**ADDENDUM NO. 03 – PORTAGE PUBLIC SCHOOLS – CENTRAL ELEMENTARY SCHOOL BP 4:
CONSTRUCTION**

ADDENDUM NO. 3 (BP4)

DATE OF ISSUANCE:	June 19, 2023
PROJECT:	Central Elementary School Bid Package 4: Construction 8422 South Westnedge Avenue Portage, MI 49002
OWNER:	Portage Public Schools
ARCHITECT'S PROJECT NO.:	21-237.10
ORIGINAL BID ISSUE DATE:	May 17, 2023

10 TYPICAL PLAN DETAIL AT MASONRY WALL WITH INTERLOCKED INTERSECTIONS
 1" = 1'-0"

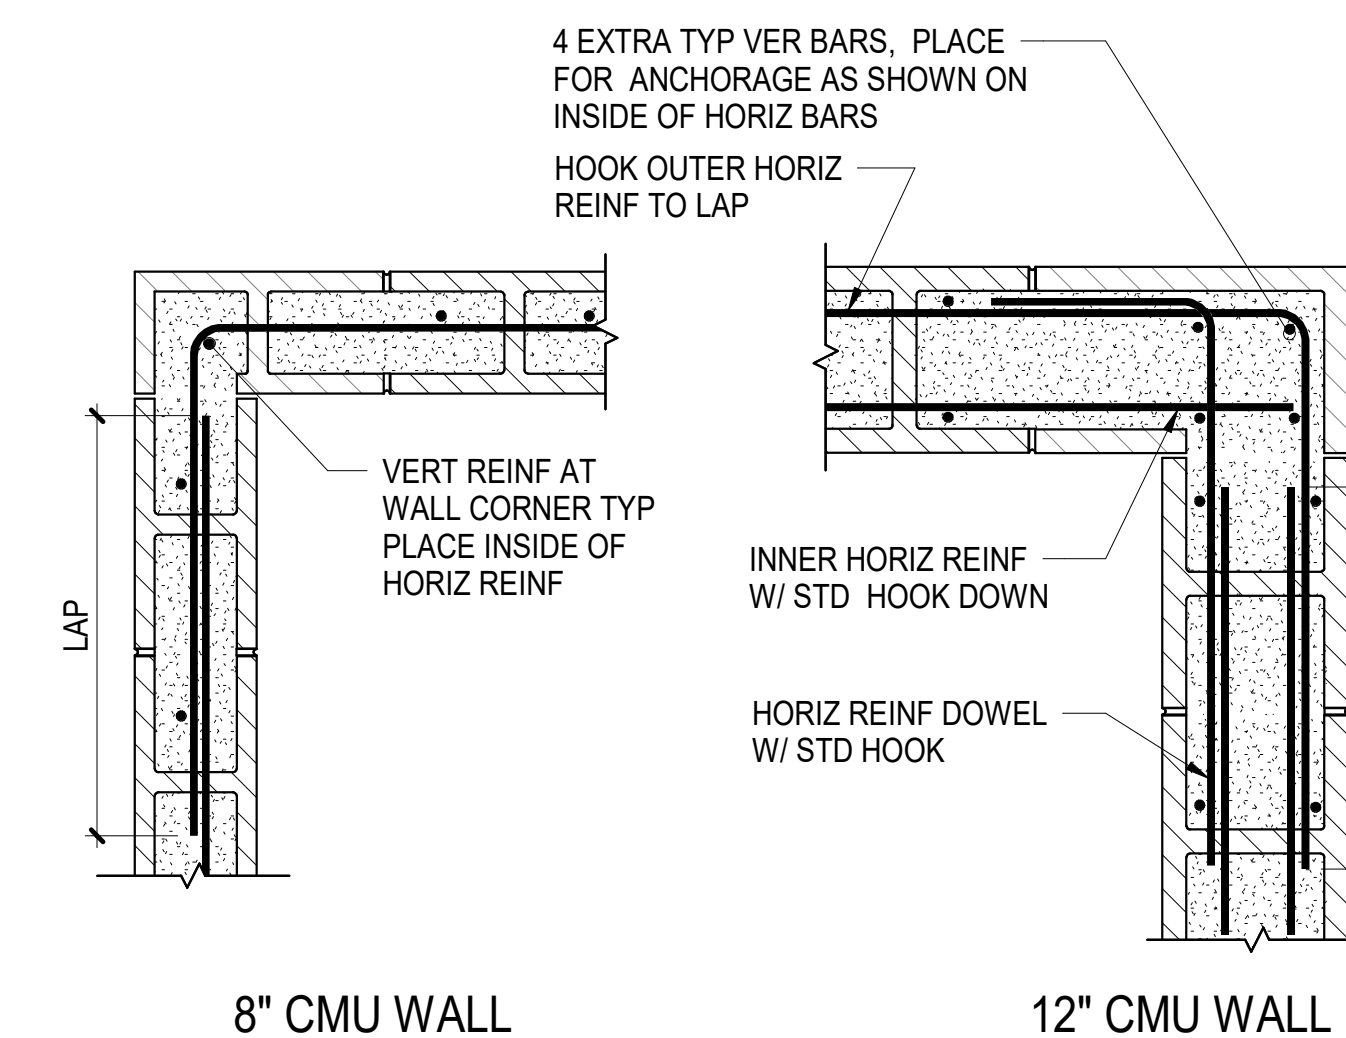
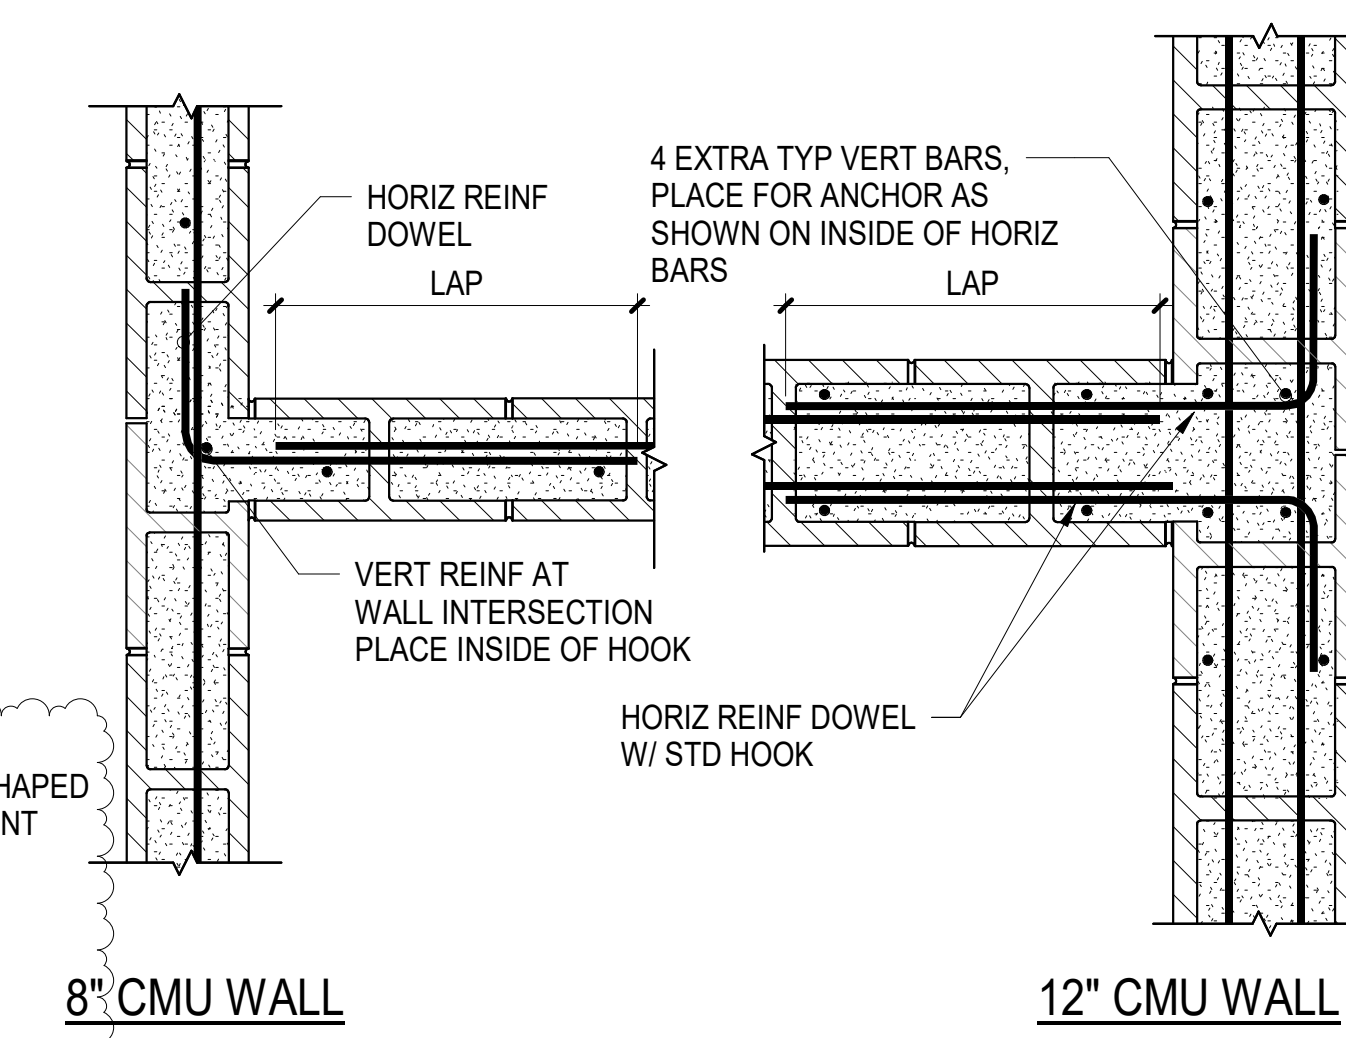
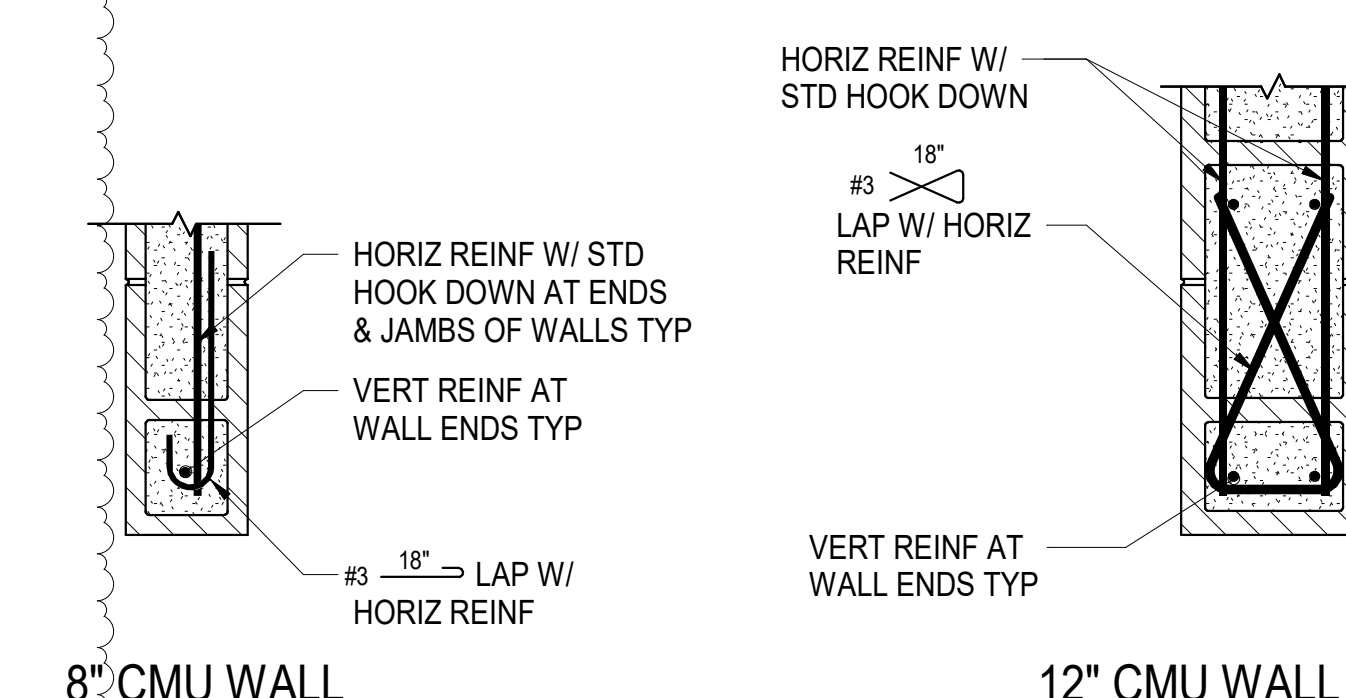
ADD-3 Item No. D-3 - CMU Horizontal Reinforcement Requirements

Horizontal reinforcement requirements for CMU walls revised to utilize ladder type horizontal reinforcement in lieu of deformed bars. Detail 10 added to clarify conditions of ladder reinforcement at wall intersections.

11 TYPICAL EXTERIOR CMU WALL AT ROOF
 FLUTES PERPENDICULAR
 NOT TO SCALE

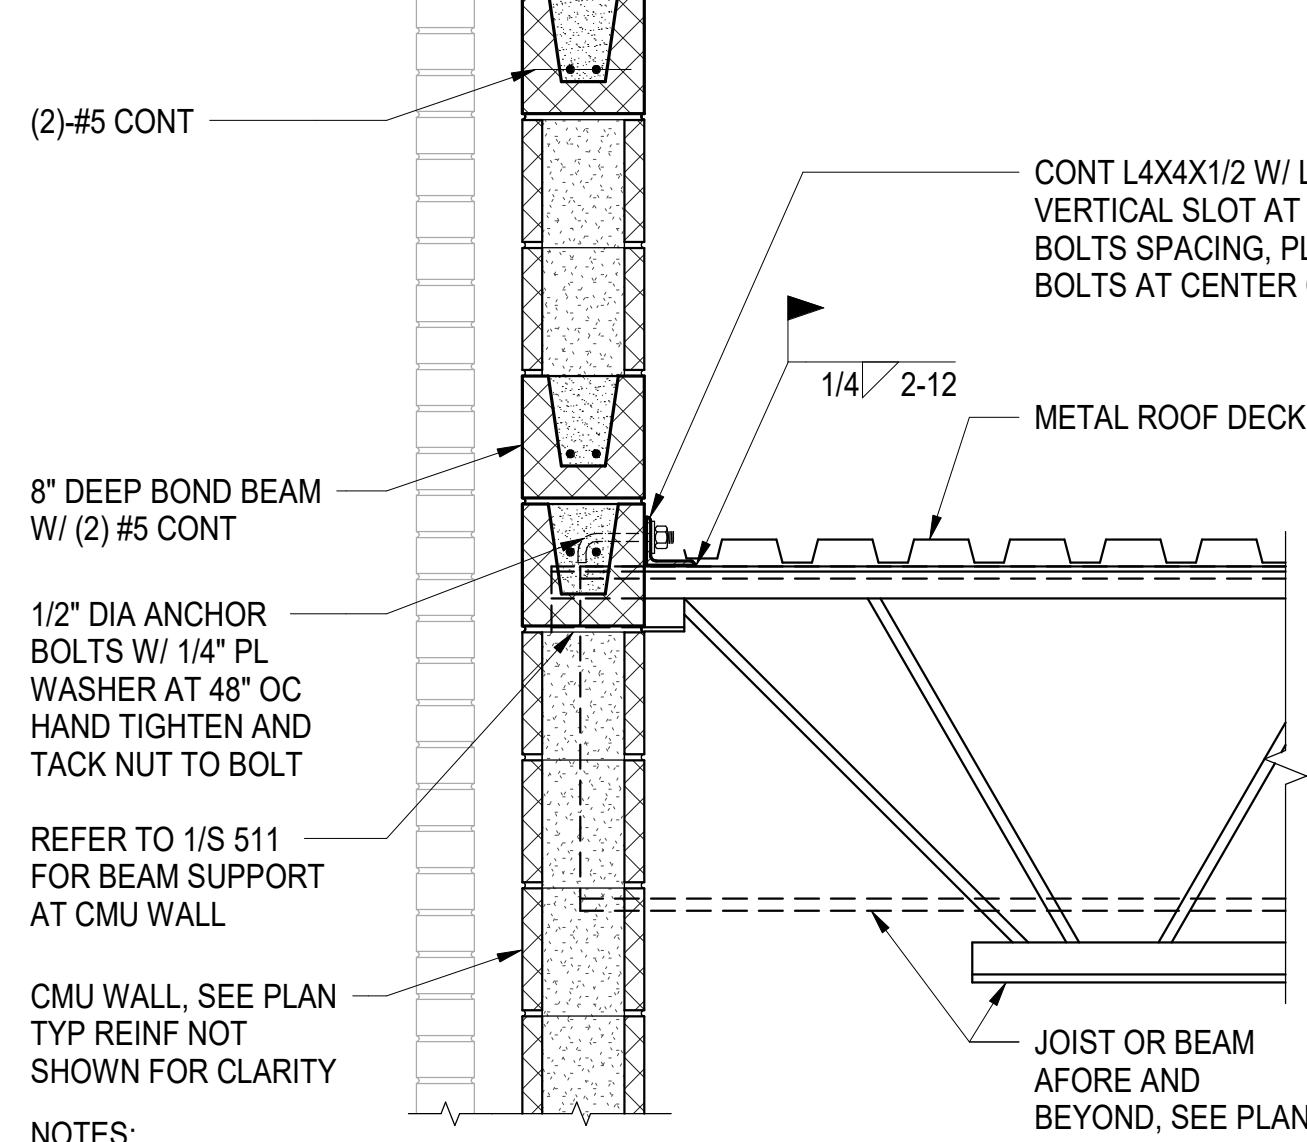
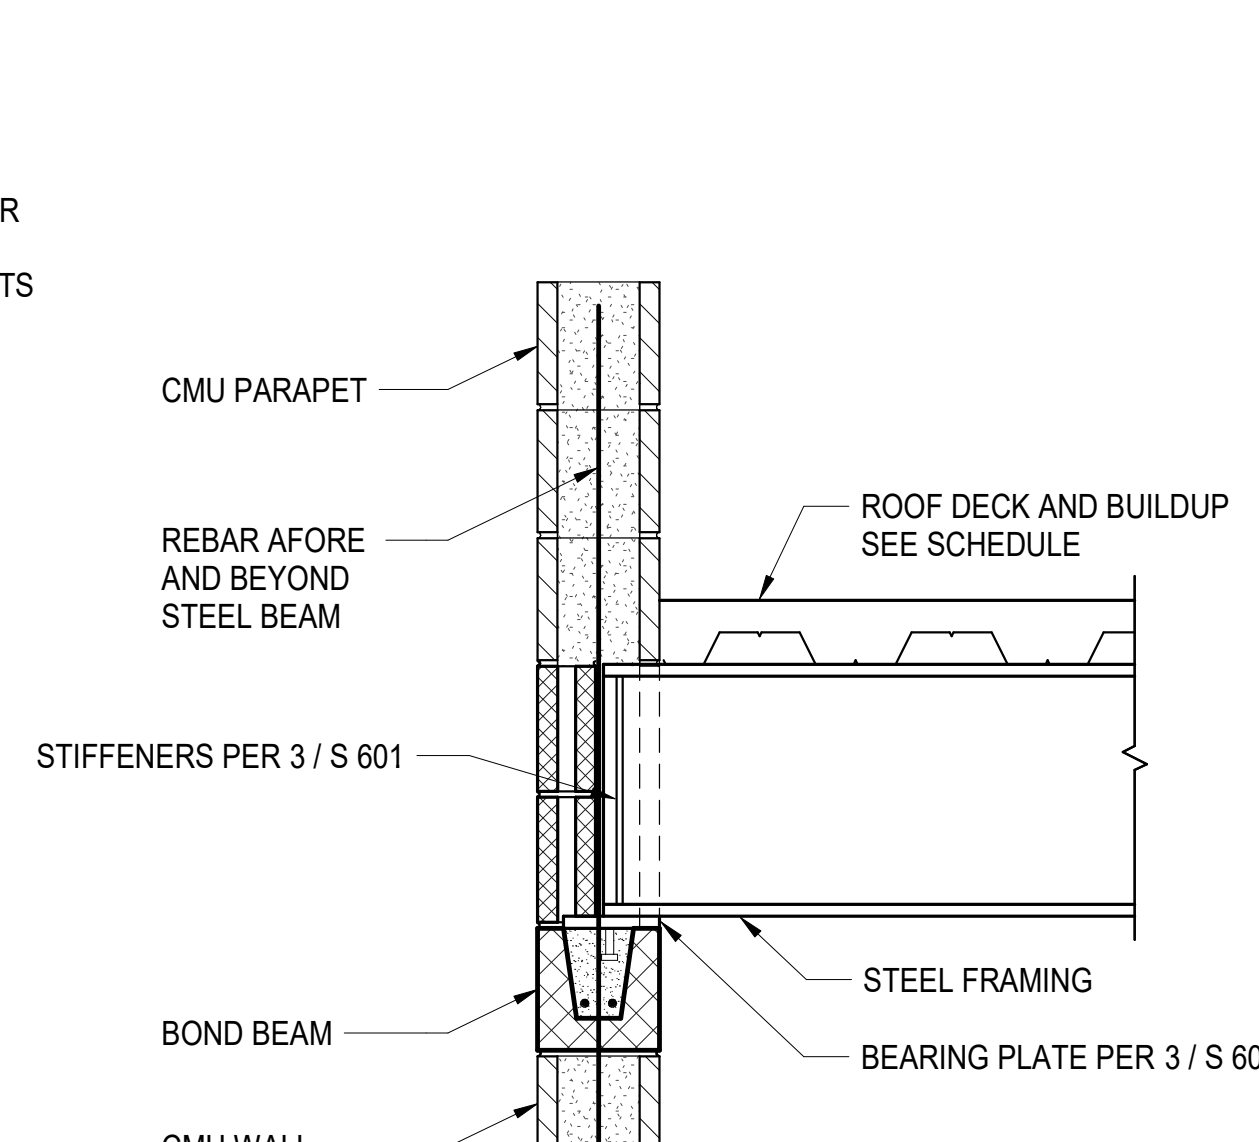
ADD 2 - BP 4 - Prebid RFI 027	Anchor Bolt in CMU Wall	Detail 11&12/S601 show a bent anchor bolt embedded in CMU wall supporting deck relief angle. This installation method is not particularly affective. Should these anchors be bid as epoxy, wedge, or screw type anchors? Scott Bruce, Van Dellen Steel, sbruce@vandellensteel.com	Base bid drawings shall be per design intent indicated on the structural drawings. Epoxy, wedge, and screw anchors may be considered as an alternate for the purposes of pricing/ bidding. Any alternates to be fully evaluated by TT as a substitution request submitted by the awarded contractor. TM(TT) - 6/14/2023
ADD 2 - BP 4 - Prebid RFI 028	Door Clarification	Opening 151A is noted on the Door Schedule as a STC42 Wood Door Type FG2. Opening 151B is also noted as a STC42 Wood Door Type FG2 with 45 Minute Fire Rating. I have been told by all of the approved manufacturers that they are unable to provide STC42 with a Type FG2 Door, they cannot provide a 45 Minute Fire Rating and they cannot provide the glass as specified. Please clarify as soon as possible how you would like these two Openings priced/manufactured? Tom Roberts, S.A. Morman & Co., troberts@samorman.com	Doors 151A and 151B - revise door type to "F" in lieu of "FG2". Maintain STC42 rating. Doors to be updated in Add. 2 as noted.M. Rossio 6/12/23
